Product/Process Change Notice - PCN 18_0190 Rev. -

PCN Title: ADUCM310/320/320i/322: Metal Edit

ADuCM320/ ADuCM320i ADuCM322/ADuCM322i PCN

Details on Silicon Change

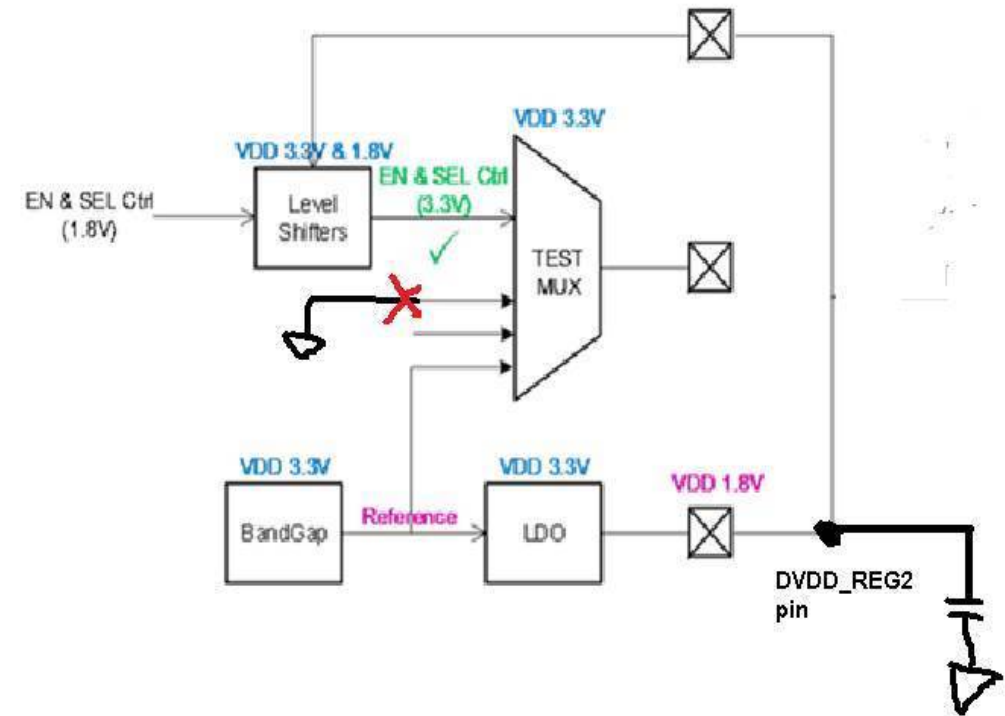
- ▶ Cut a single track to disconnect a grounded input to a Test Mux – see the red “x” below to indicate the location.
- ▶ When the 3.3V DVDD power supply is rising from 0V towards the Power-On reset threshold voltage, the enable and select signals to the Test MUX shown below are undefined.
- ▶ In some corner cases on previous silicon, this sometimes resulted in the output of the Bandgap being shorted to the GND input of the MUX.
- ▶ This meant that the digital LDO did not get a valid bandgap voltage and did not power up correctly.
- ▶ The digital LDO output is 1.8V and is required for the Cortex-M3 and other digital peripherals to operate properly.
- ▶ In the failing cases, this 1.8V rail did not come up properly and led to the Cortex-M3 never executing user code
